STAFF REPORT
WEST ALLIS PLAN COMMISSION
Wednesday, December 11, 2024
6:00 PM

4. Site, Landscaping, and Architectural Design Review for La Finca, a proposed Restaurant (limited), at 7033 W. National Ave. (Tax Key No. 453-0602-000).

Station No. 6 Outdoor Patio (former parking area)

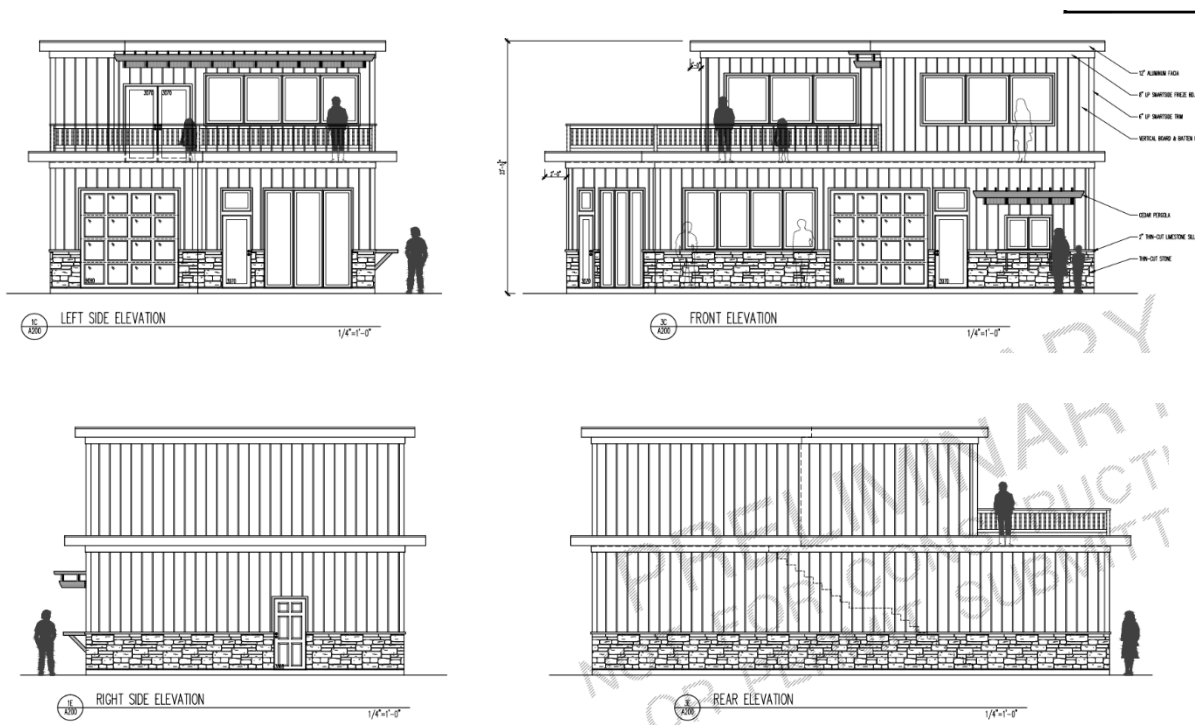
The difficulty of utilizing the concrete area for parking may provide the proposed business with additional space that may be used as an outdoor patio, food truck hub, or another community-focused amenity. These uses for the concrete area would align with the National Ave corridor plan in terms of enhancing streetscape appeal and fostering vibrant social spaces which will be bolstered by the proposed user La Finca.

A similar pattern of use can be found in West Allis at Station No. 6. The property at Station No. 6 was formerly used for a light motor vehicle service. The former concrete area used for parking & maintenance of vehicles was transformed into a vibrant patio for patrons to utilize. A similar type of use is recommended by staff for this project.

Staff would like to also note that the site does not have a refuse enclosure. Staff have included a recommendation to screen any refuse areas with a four-sided refuse enclosure. The Design Review Guidelines state that refuse areas should be placed away from street-facing facades. Given the lack of space for a rear refuse area, this requirement may be difficult to meet. The applicant should seek to consolidate trash collection. The applicant should seek to consolidate trash collection with the parking lot they own to the south of the alley.

1. Site plan & Landscaping being submitted to the Planning and Zoning Office showing (a) access point revisions on W. National Ave. & S. 71st St with approval from the City Engineer, (b) a designated use of the concrete area (e.g. parking, patio, or other amenities), (c) the location of any refuse areas

and 4-sided screening details including consideration of locating refuse area south of alley, (d) the applicant apply for a Commercial On-Street Accessibility Parking Zone permit; (e) removal of test areas of existing metal panel siding to explore restoration of brick as an option of adding new siding; (f) landscaping amenities being located on site including planter boxes, wall-mounted planters, trellises, or other features to enhance streetscape and buffer adjacent properties (g) location of any lighting on the site.

FIRST FLOOR DEMOLITION PLAN
FIRST FLOOR PLAN
SECOND FLOOR PLAN

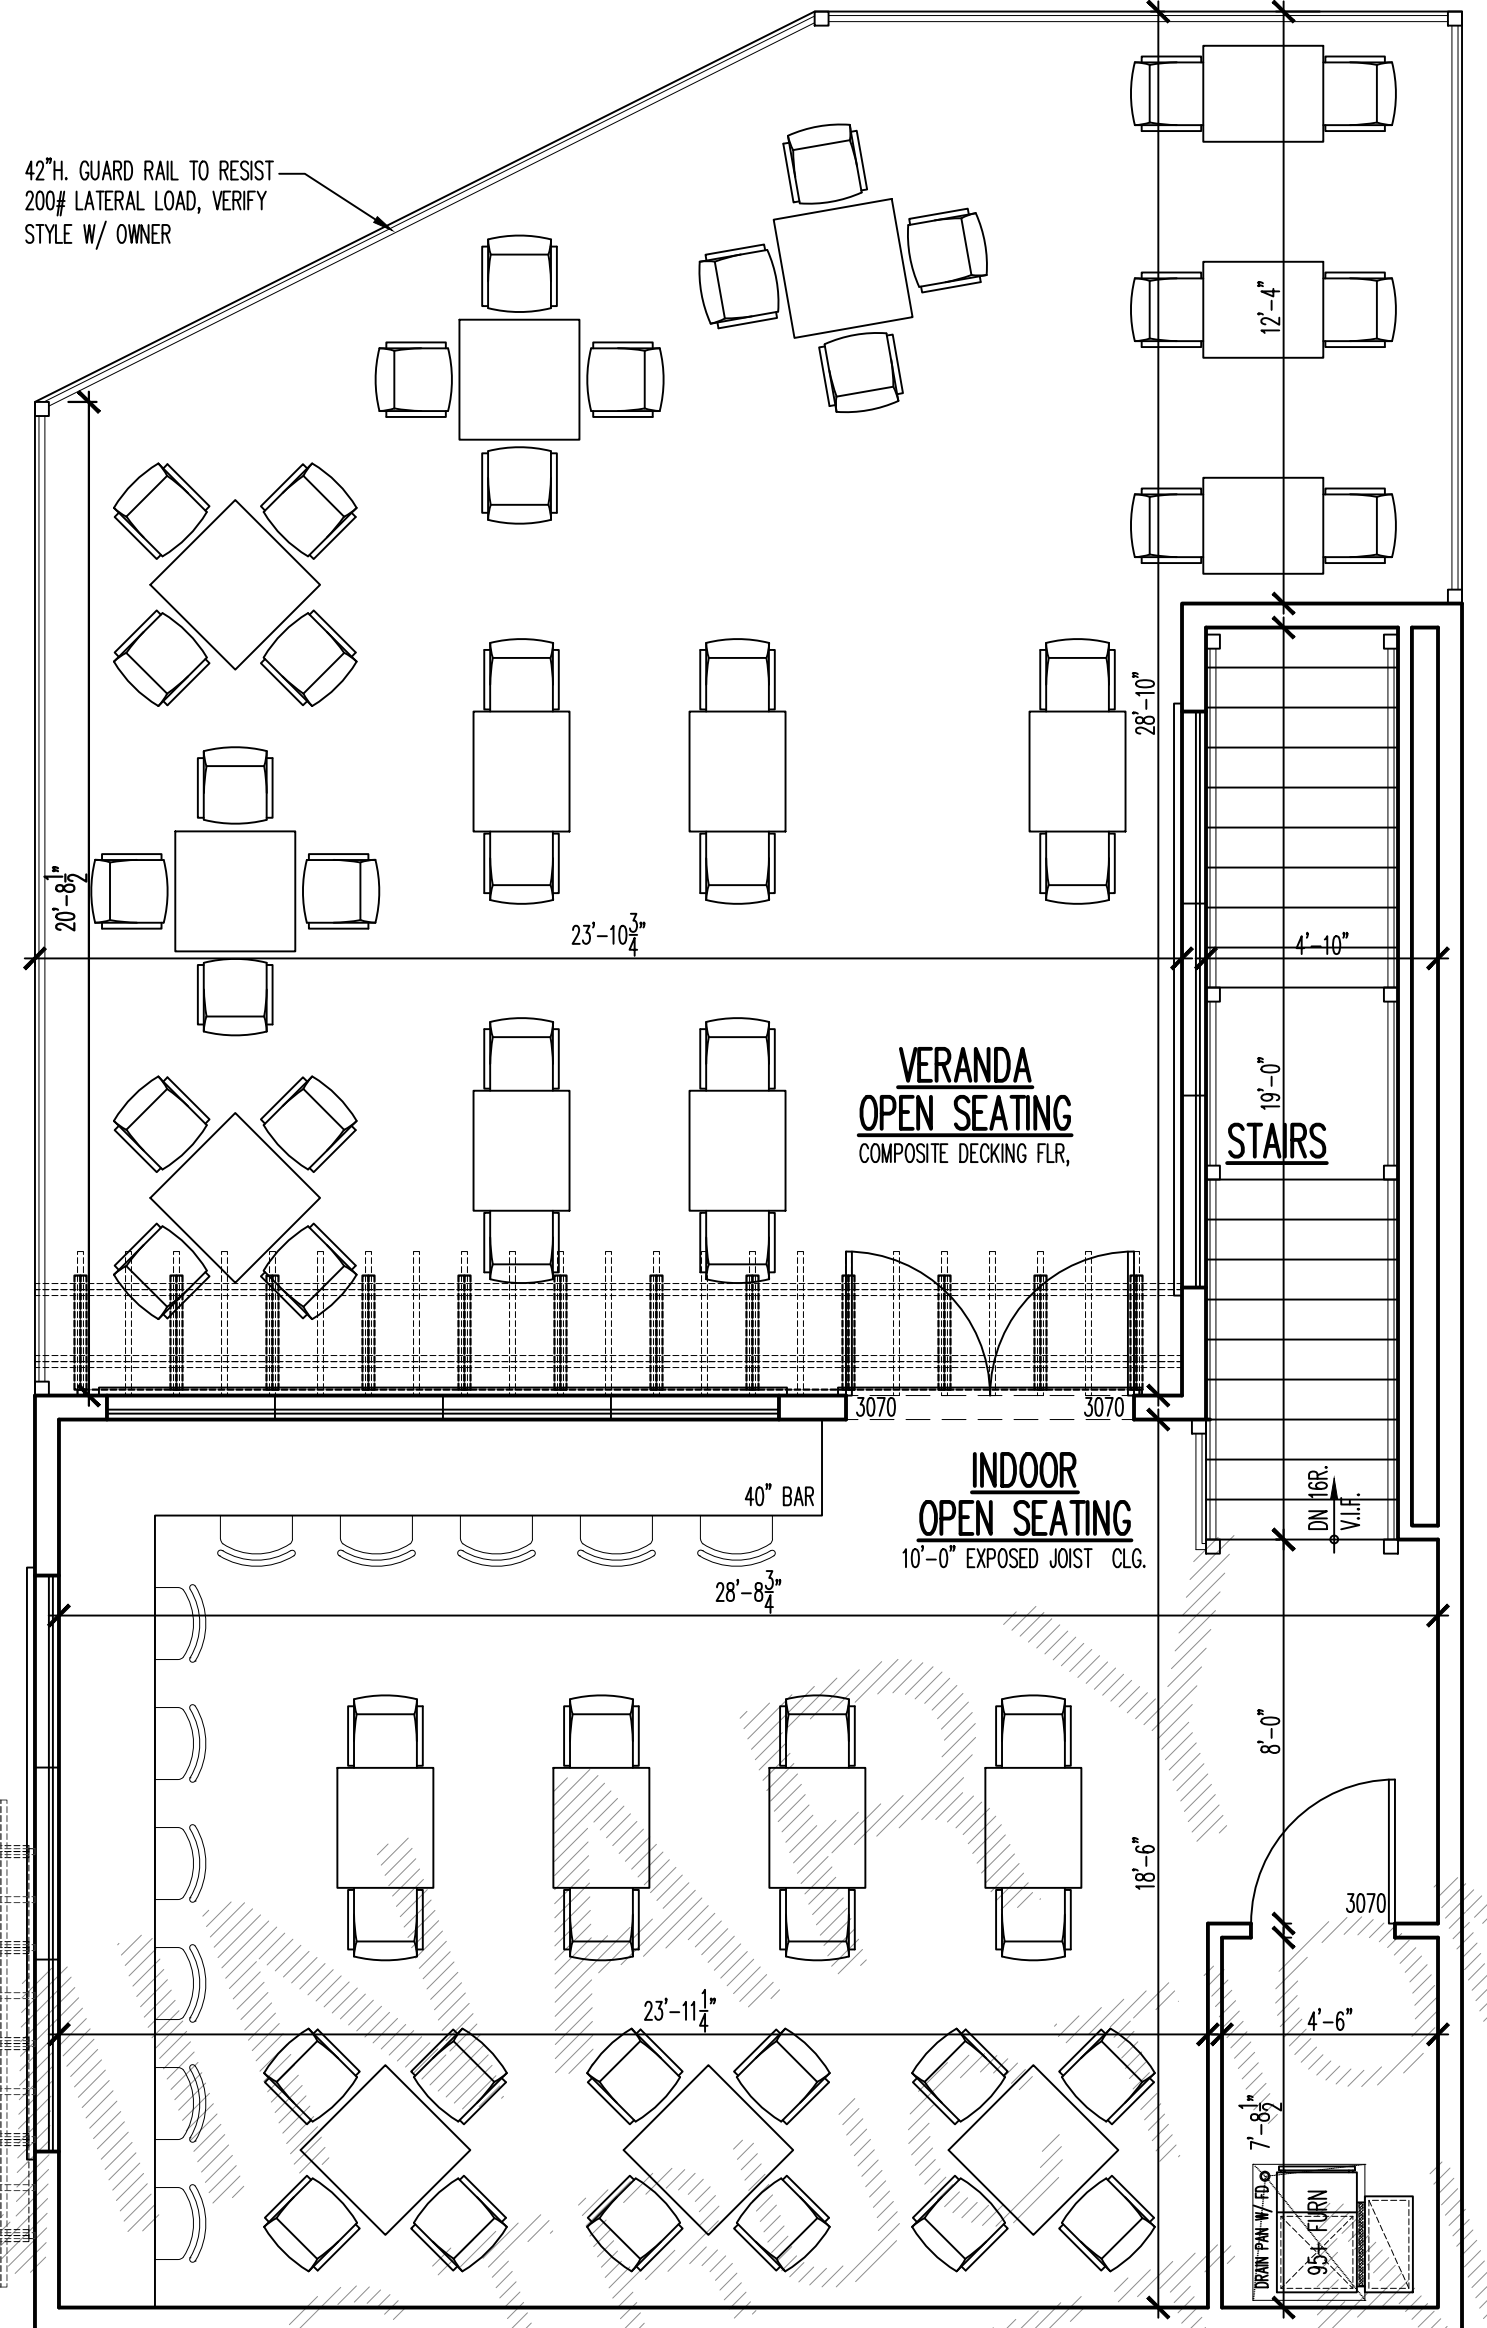
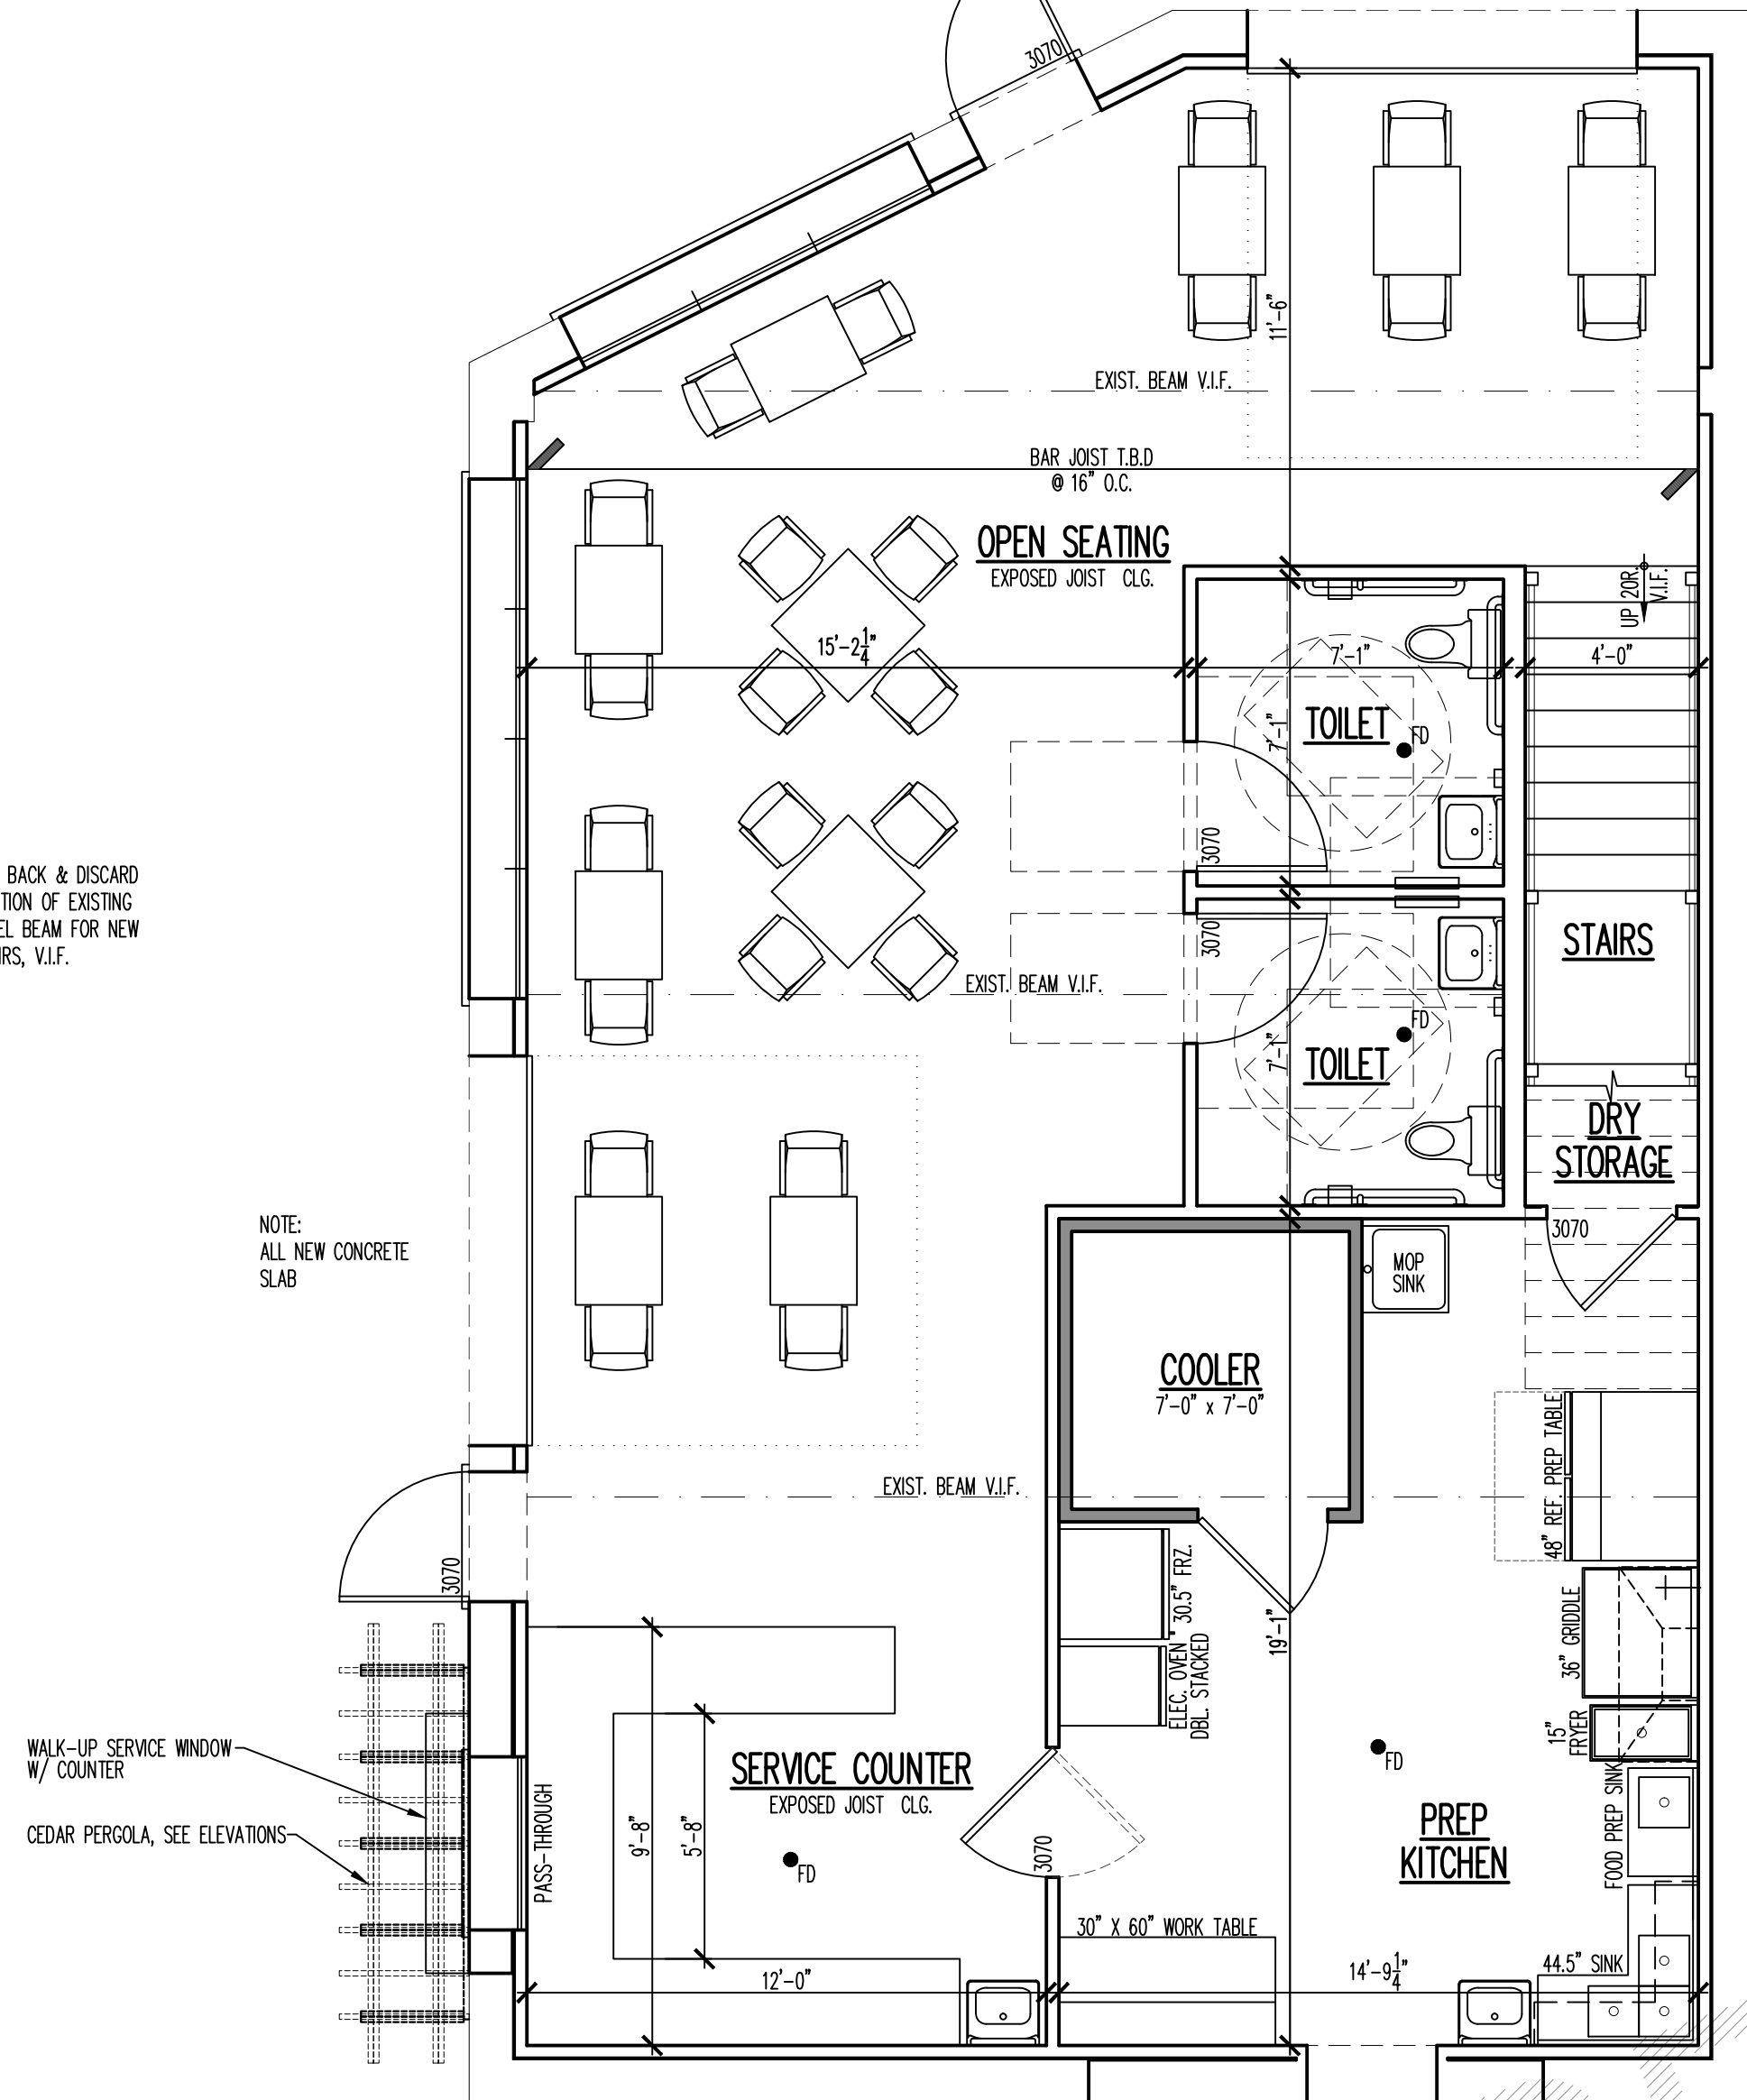
The proposed business shows a revamped floor plan to accommodate for the restaurant use. Customer access to the first floor of the restaurant is provided by entry doors on the north and west sides of the building. Overhead garage doors can also be found providing access to the north and west sides of the building. The floor plan shows an open seating concept making up most of the first floor. Two restrooms are shown along with a prep kitchen, cooler, and dry storage area. Stairs

in the east portion of the building provide access to the second floor. The second floor shows an open seating area with tables and chairs, along with countertop seating. A utility closet is also shown. The indoor area leads directly to the outdoor patio area which includes additional seating.
